MP 06 0147

**PREFERRED PROJECT REPORT
and RESPONSE TO SUBMISSIONS.**

**Proposed 7 Lot Rural Subdivision and
Boundary Adjustment at Lot 14 DP 750222
and Lot B 33573, off Ivor Jones Drive,
Wonboyn Lake, NSW.**

9 July 2010

Figure 2.2: Vegetation Communities

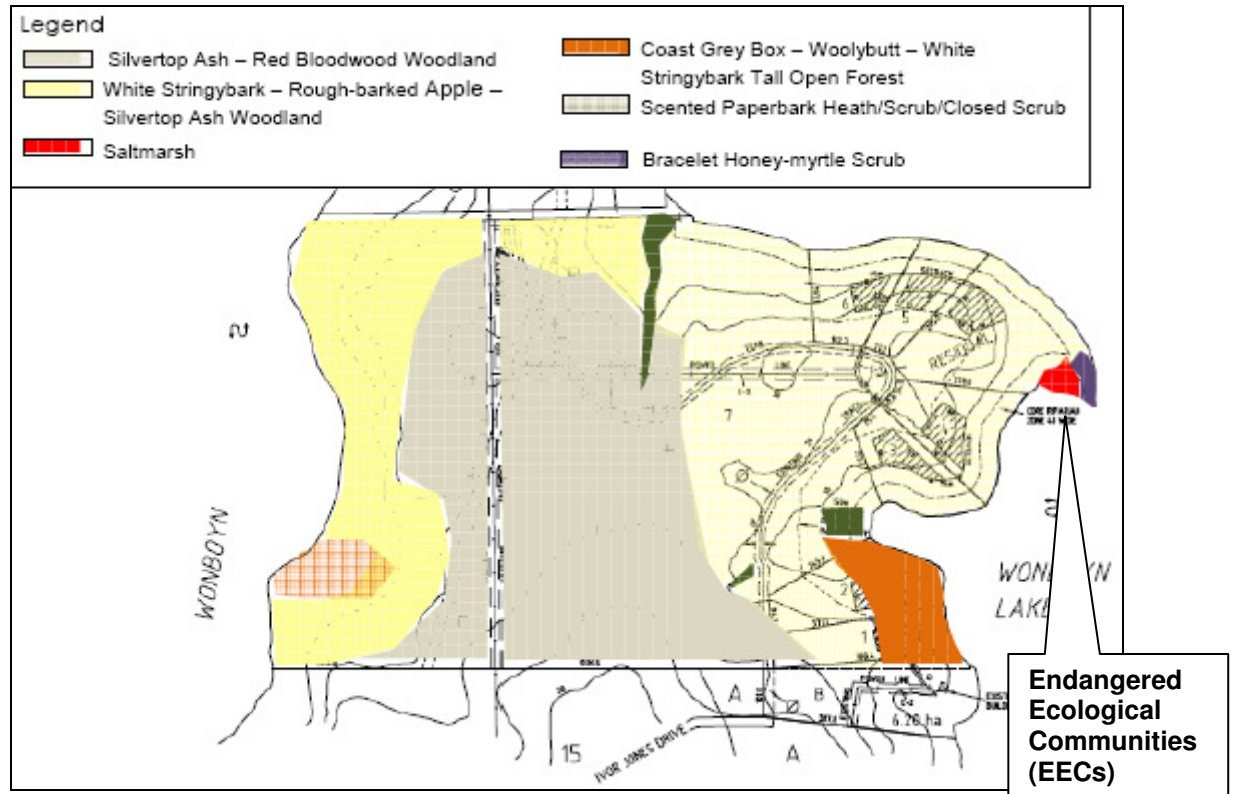
Restrictions to conserve Endangered Ecological Communities (EECs) are considered in Section 4 of the Updated LesryK report (see **Appendix C**). Vegetation Communities are illustrated in **Figure 2.2**.

There will be no clearing of Saltmarsh or Bracelet Honey-myrtle Scrub as a result of the proposed development - these two vegetation types being examples of the endangered ecological communities Coastal Saltmarsh and Swamp Oak Floodplain Forest, respectively. Nevertheless, these communities would be protected by covenants (where they occur above the mean high water mark) and by erection of signage indicating their conservation significance and sensitivity to disturbance.

Figure 3.1: Route to and from Princes Highway

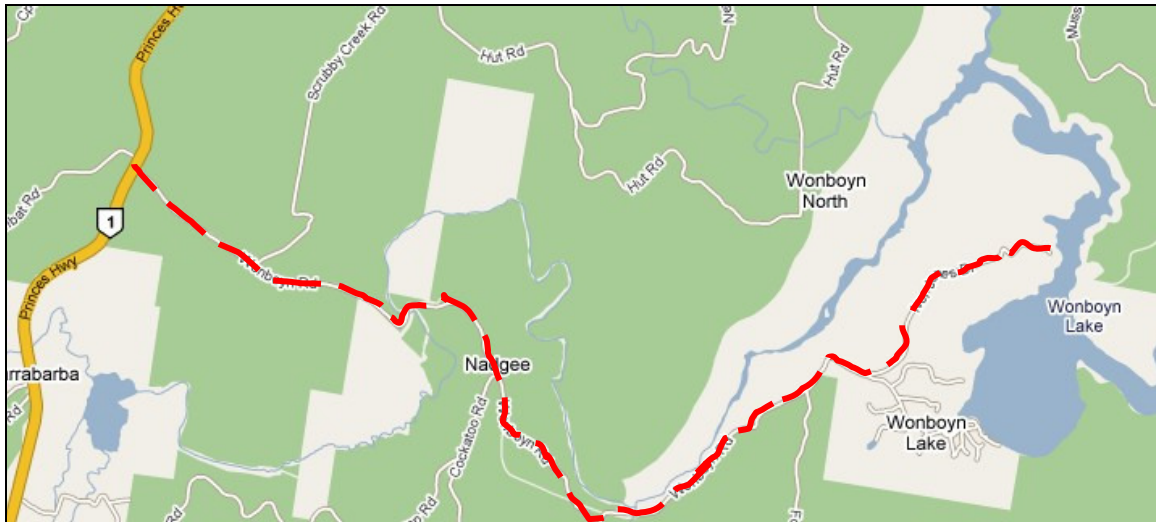
While it is known that the Wonboyn River does, from time to time, experience flooding, the exact extent of the rise in water levels at these times is unknown. Enquiries with Bega Valley Shire Council by RW Surveys and Valuations have confirmed that they hold no flooding data of the Wonboyn River.

Given the small population of the Wonboyn Village, there is no current warning or evacuation plan for the town, in the event of a flood. In the past, flooding of the main road has occurred at a frequency of approximately once annually, and can last up to 3 days, with most residents unable to leave until such time as the water levels recede. The “main road” referred to is Wonboyn Road. The route to and from the site from the Princes Highway along Wonboyn Road is illustrated in **Figure 3.1**.

The Watergums Creek Bridge (one of the main bridges subject to flooding) was upgraded by Bega Valley Shire Council in 2007. This bridge was inundated with water and the Wonboyn Road was closed by Council in early 2010.

Figure 5.2: Typical Cross Section – Private Right of Way

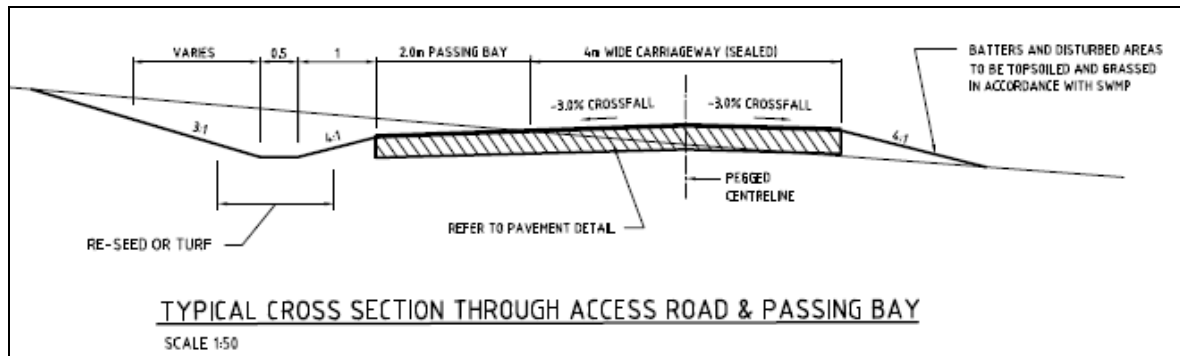
As requested, further clarification and justification of the proposed passing bays is detailed in the revised Traffic Report (see **Appendix E**) and summarised below.

The first part of the Type 2 Road – Private Right of Way runs from Ch 00 to 750 and contains 5 passing bays (located at distances approximately 110m to 145m apart). This first part of the Private Right of Way from Ivor Jones Drive, services existing lot B and proposed lots 1, 2 and 3. Turning facilities are available within the driveway entrances to Lot B, and Lots 1 to 3. A typical cross section is attached as **Figure 5.2**.

Figure 6.1a.: NSW Acid Sulfate Soil Risk Map Extract (Site outlined in orange)

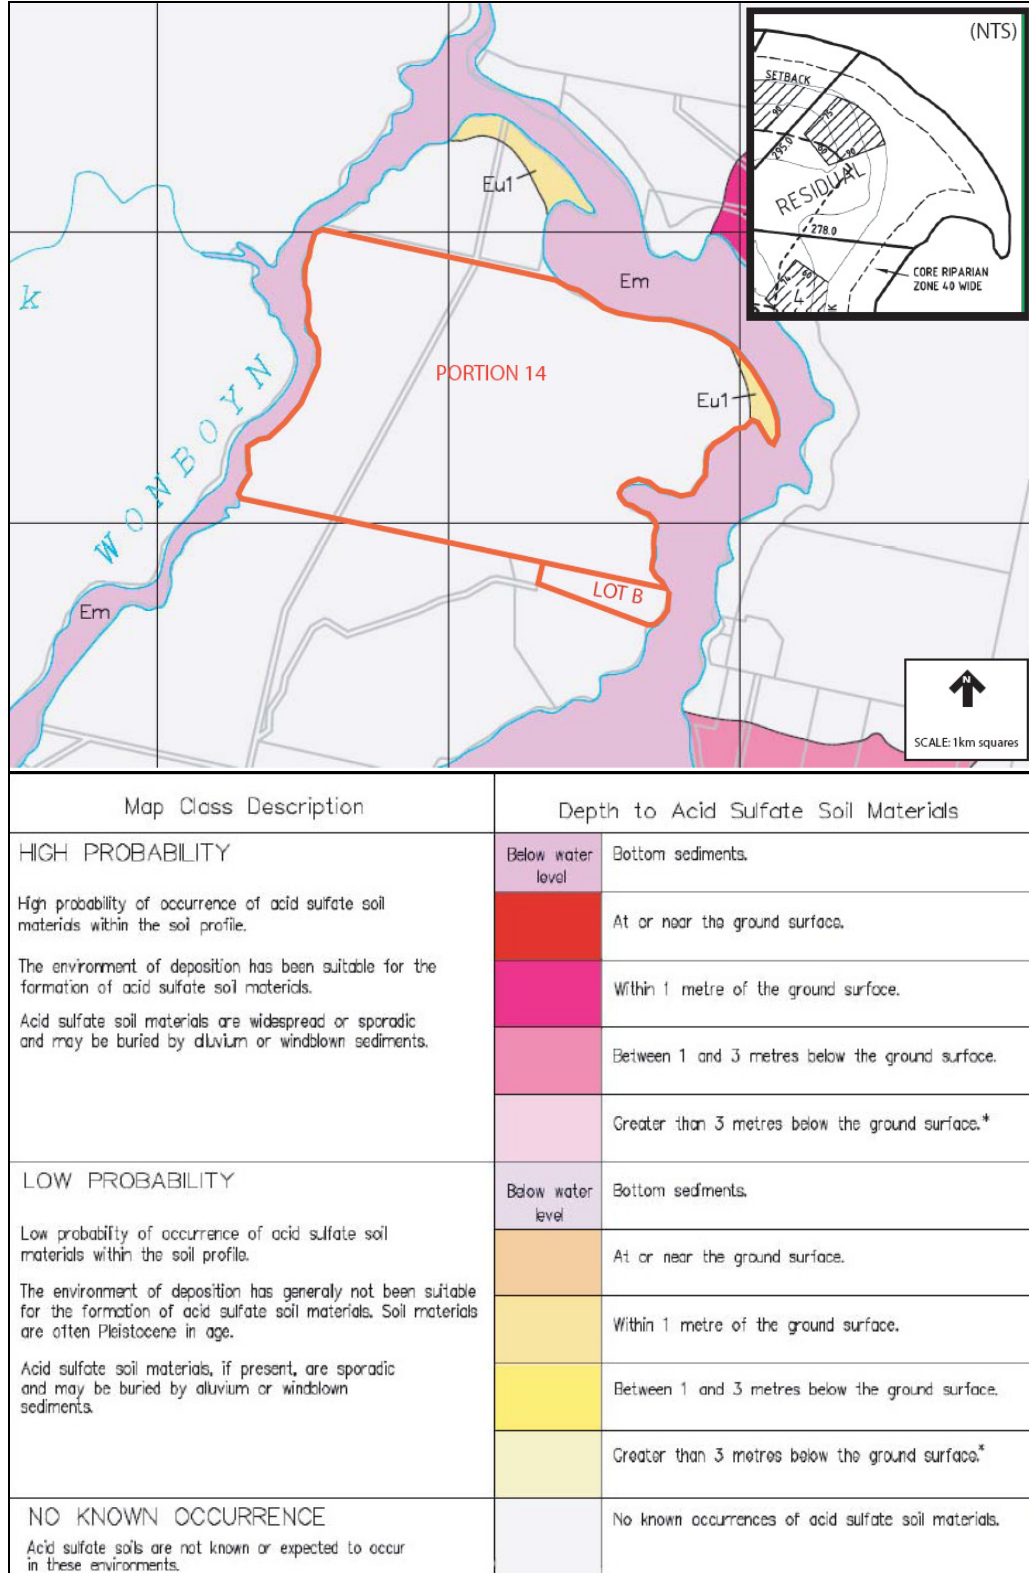
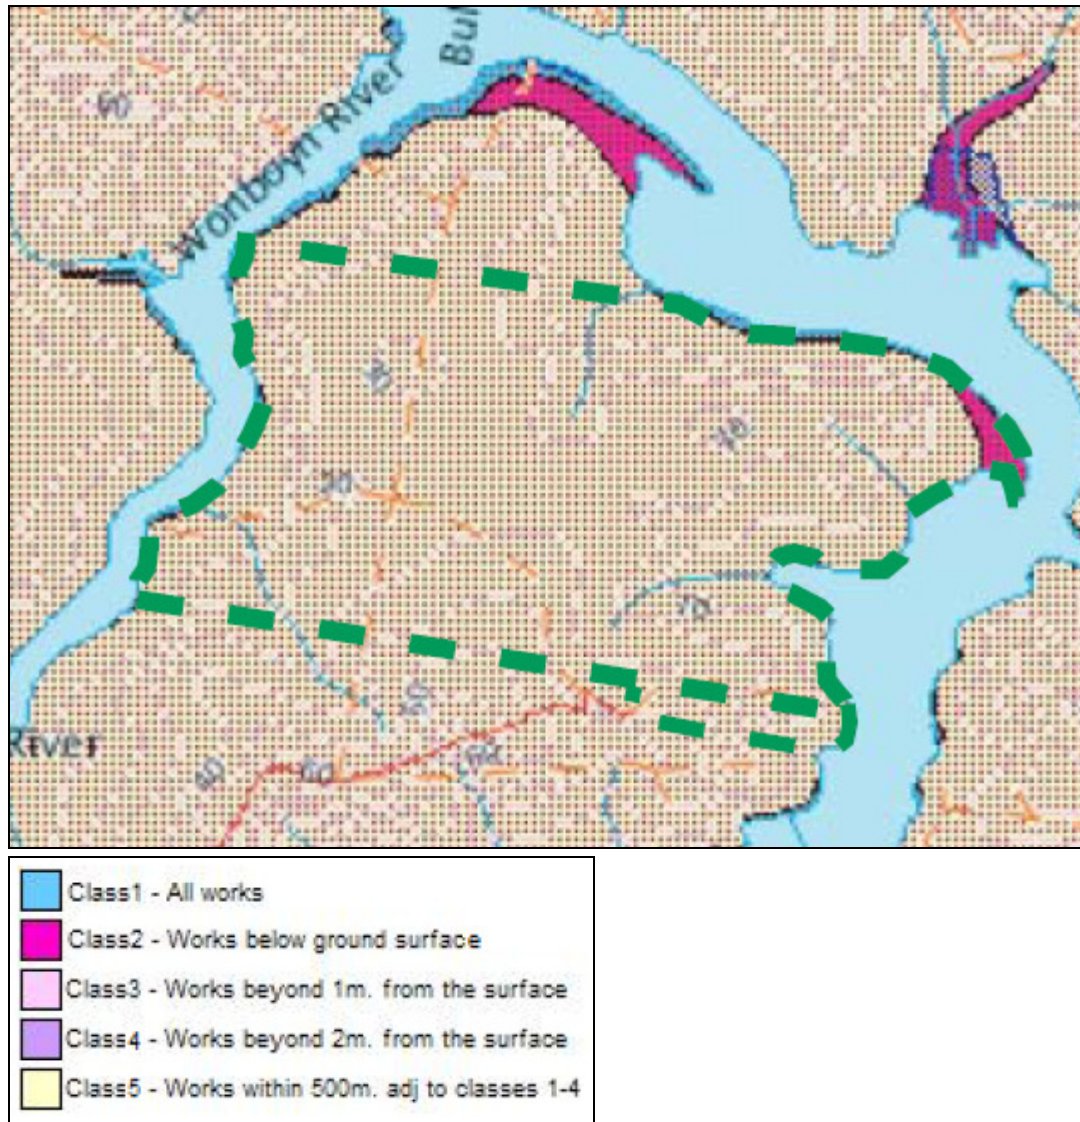
This section addresses Key Issue 5 of the DoP's concerns. Acid Sulfate Soils (AS Soils) were previously considered in Section 11.13 and Section 14 of the EA. AS Soils are considered in the revised WCMS Section 3.2.7 Acid Sulfate Soils (SEPP 62) (see **Appendix D**). Clause 82 of the BV LEP 2002 is also relevant in the consideration of Acid Sulfate Soils.

AS Soils risk mapping by the Department of Land and Water Conservation (DLWC, now part of DECCW) identified several small patches of coastal land in proximity of this site that have a high risk of being ASS (see **Figure 6.1**). There is a small area of foreshore on the site within residual lot 7 that contains soils identified on the DECCW map as having a low probability of containing AS Soil to 1m-3m below the surface. Although SEEC did not specifically investigate this area for acid sulphate soils, they concur that there may be a high risk of AS Soils in this area (see areas coloured yellow and reference Eu1 within **Figure 6.1**).

However, none of the proposed development is (in plan) near any of these AS Soils locations and, more importantly, all proposed development is on relatively elevated lands, well above AHD 10 m. The potential AS Soils are also within the 40m Riparian Corridor where there will be no disturbance to the soils. Therefore, SEEC have assessed that there is no risk that acid sulfate soils will occur in any of the proposed development sites.

Clause 82 has been considered, as the subject site is located within an area identified as containing ASS in the NSW Acid Sulphate Soil Planning Maps (see **section 6.2.1** above). The requirements of Clause 82 have however not been considered to apply to the proposed development as:

- The identified potential AS soils are generally along the foreshore edge of the site and do not extend beyond 75m from the High Water Mark (which defines the "building setback"),
- The identified potential AS soils are "low-probability" as per Figure 6.1a above,
- Generally no "works" are proposed within the 40m Riparian Corridor or the 75m building setback which is the only area of potential AS soils,
- The proposed "works" as part of this subdivision application do not fall within the definition of Clause 82(2)(a), and
- the proposed works which are the subject of this application will not lead to the lowering of the watertable as outlined in Clause 82(2)(b).

Figure 7.1: NSW Agricultural Land Classification Map

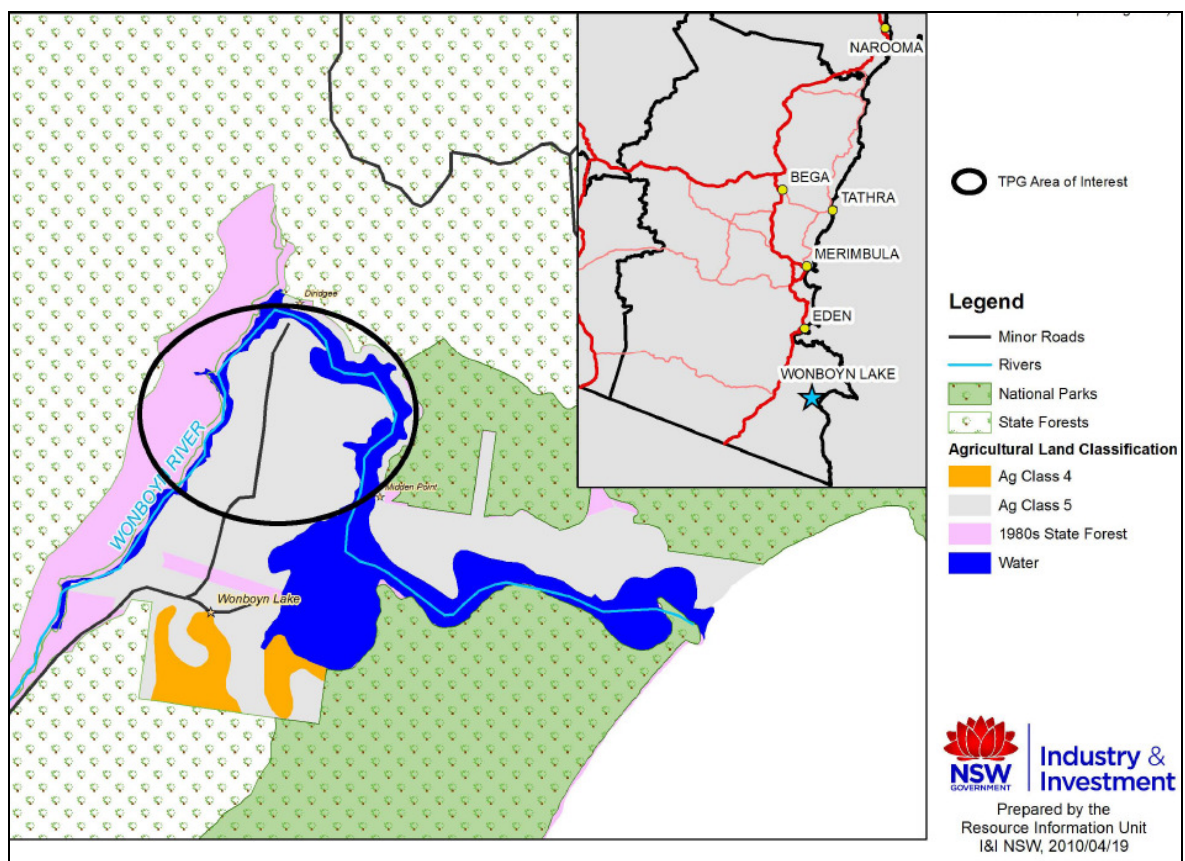
(i) NSW ASS Planning Map	Section 6.2
(ii) consider CI 82 BVLEP 2002	Section 6.3
6 – Agricultural Land classification	Section 7
Introduction	Section 7.1
Outside of Class 1 or 2 agricultural lands?	
NSW Agricultural Land System	Section 7.2
7 – Bushfire	Section 8 and Appendix E
Amended Bushfire Report required	Section 8.1

The subject site is on land which is Class 5 Agricultural Land, as identified in **Figure 7.1**. Class 5 land is defined in Agfact AC.25 as:

Class 5: Land unsuitable for agriculture, or at best suited only to light grazing. Agricultural production is very low or zero as a result of severe constraints, including economic factors which prevent land improvement.

Figure 9.3: Riparian Zone

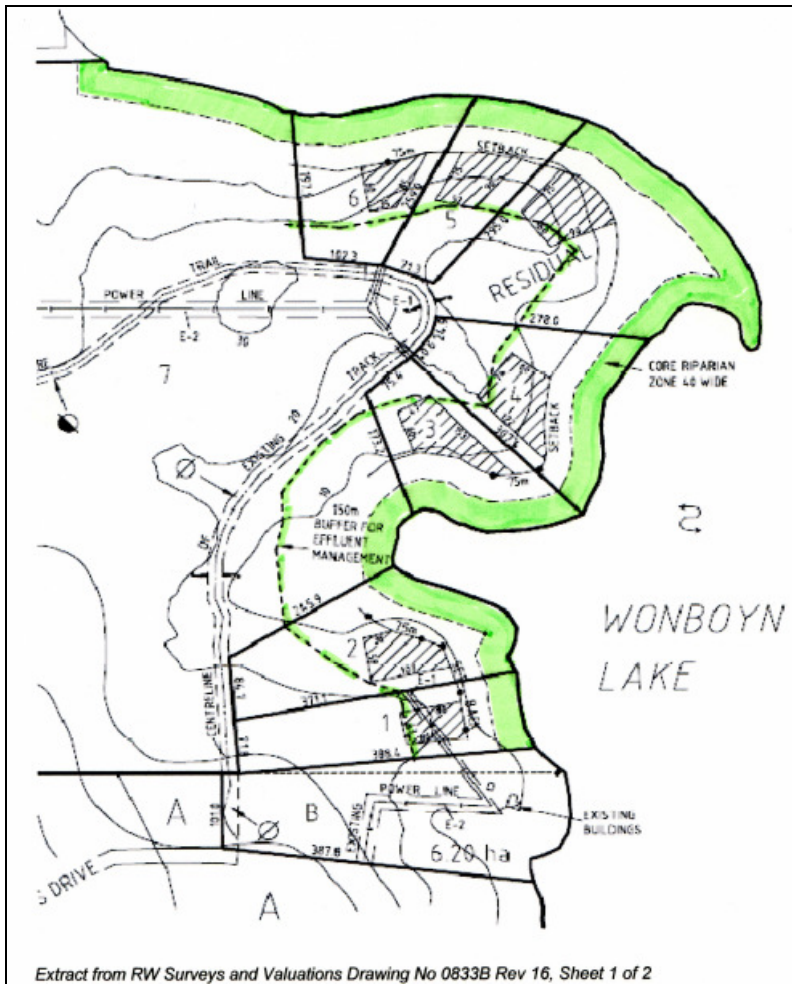
As requested, a 40m Core Riparian Zone (CRZ) is provided as part of the proposed development. The CRZ is included within **Figure 9.3** (see also RWS Drawing no 0833B

The proposal includes a building setback of 75m from the high water mark of Wonboyn Lake. The setback from the water provides a zone in which building envelopes, roads and easements are excluded. The setback line also marks the boundary between the 7(b) (Environment Protection Foreshore) zoned land (water side) and the 1(a) zoned land (land side) – see **Figure 9.2**. This 75m setback will ensure that existing riparian vegetation is maintained along the foreshore within the 7(b) zoned land. The minimum 75m setback of a building from a nominated waterway is also a requirement of BVSC DCP No 6.

Figure 9.4: Location of possible Effluent Management Areas (green squares)

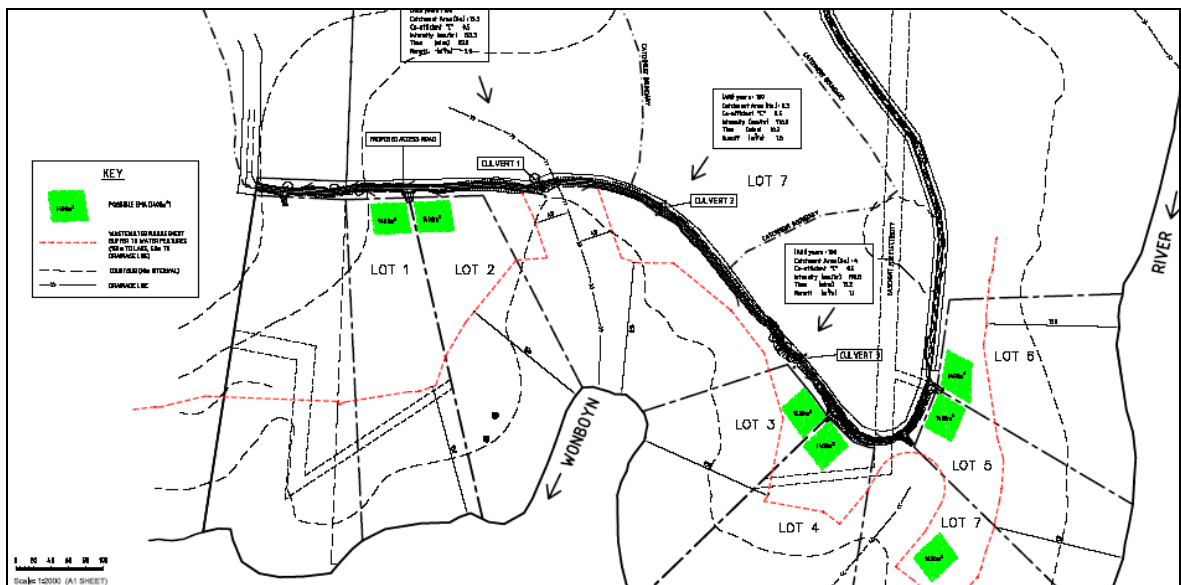
3.1.5 (v) Scaled Plan of EMAs

A minimum 150m setback from nominated waterways (ie Wonboyn Lake) for the installation of on-site effluent management systems (EMS) has been accepted as part of this development proposal in accordance with the requirements of BVSC DCP6. The identified areas for the possible Effluent Management Areas (EMA) are all in excess of the minimum 1,400m² area requirement and are all located outside the distance of 150m from the lake, and 40m from the nearest drainage line (see SEEC Drawing no 01 / Project No 10000001 – **Figure 9.4**).
